Loucas Zahos Architects

Variation to DA 020/0023/14A for increase in overall height of development by 3.4 metres, internal floor and layout changes, 66 residential apartments over 18 levels, additional studio space, two basement levels and reduced car parking.

261-263 Pulteney Street Adelaide

DA 020/0023/14A V1

GR GROUND FLOOR & SITE PLAN
1 : 100 SCALE

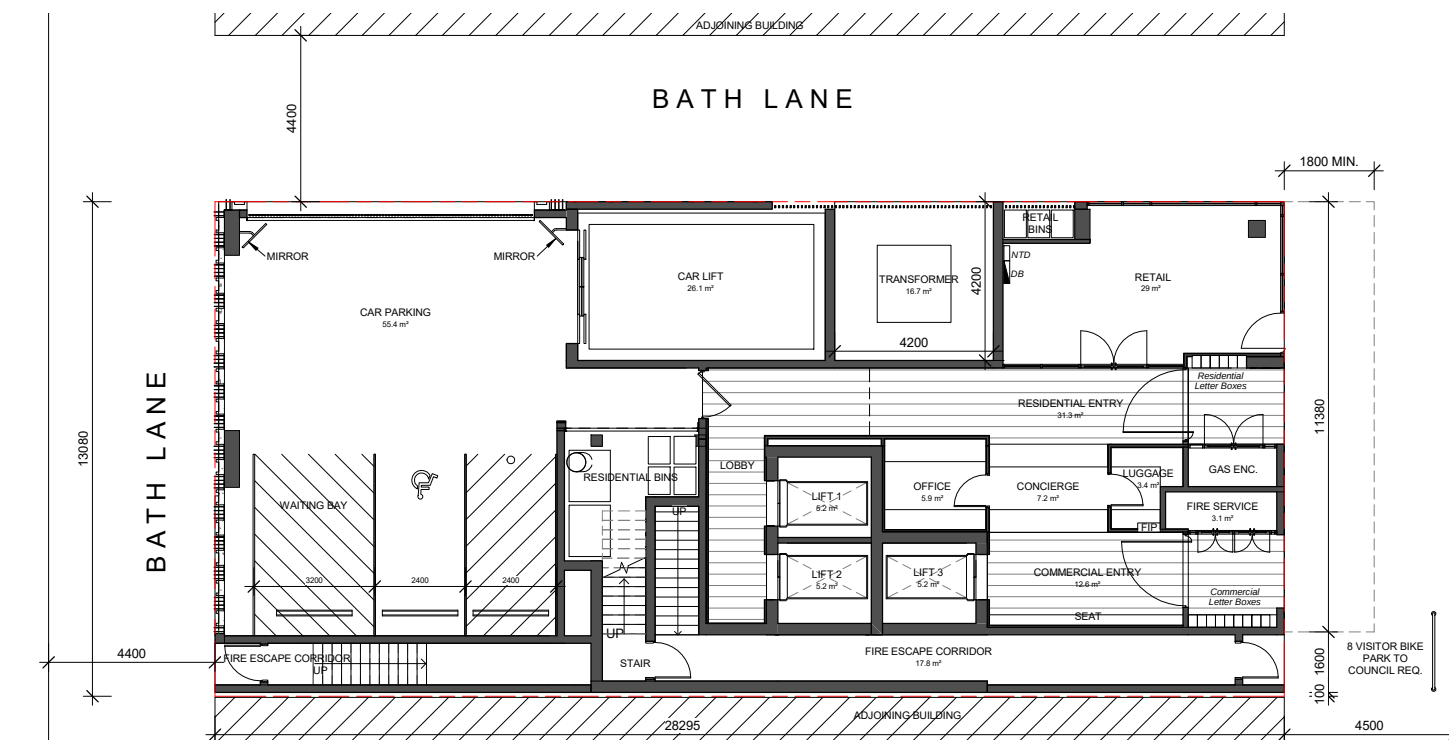
- Insufficient sight distance exists between the driveway exit and Bath Lane. Appropriate measures need to be implemented to address the sight deficiency here to enable the access to operate safely.
- Clarification is required on the provision of bicycle parking at ground level, as described by the traffic report, but not shown in the Architectural drawing set. Visitor bicycle parking at ground floor should be provided.
- Concern is raised about the potential for unwanted activity within the secluded space forward of the fire exit door to Pulteney Street

Council raised concern about the potential for unwanted activity within the secluded space forward of the fire exit door to Pulteney Street. The fire door has been revised and moved closer to the site boundary minimising the potential for activity within the exit space.

The applicant revised the plans with Council acknowledging that the applicant has addressed the above concerns raised from a traffic perspective.

In response the traffic circulation proposed was revised to provide vehicle storage bays and a revised parking layout. Mirrors were also provided either side of the opening to Bath Lane to provide improved sight lines for drivers exiting the car park. Council has since advised the applicant has addressed the concerns raised from a traffic perspective.

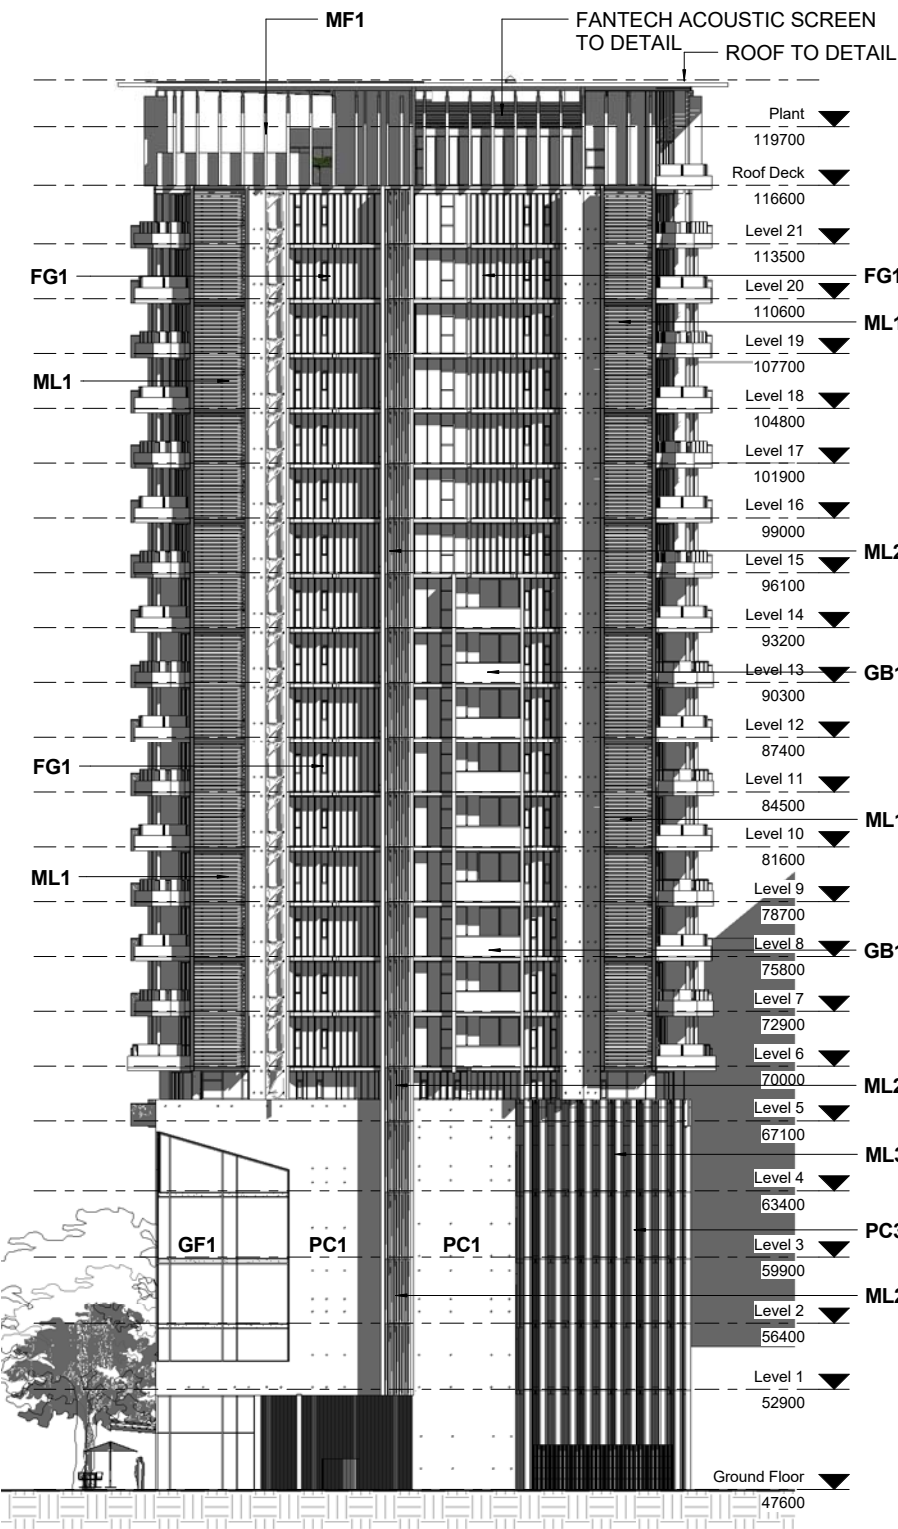
- Review of materiality of the garage door on the northern elevation
- Review of the balcony sizes to provide adequately sized private open spaces that offer a high level of residential amenity

The applicant revised the plans with the GA supporting the revised finish to the north facing garage door with vertical metal battens and supports the removal of the horizontal element above the garage door. The GA recommends matching of the metal batten colour/finish to the surrounding metal cladding.

The GA recommended a review of the materiality of the garage door on the northern elevation. This was revised by the applicant to a vertical metal batten sectional door to allow for a level of transparency between the battens to provide visibility and ventilation and is now supported by the GA.
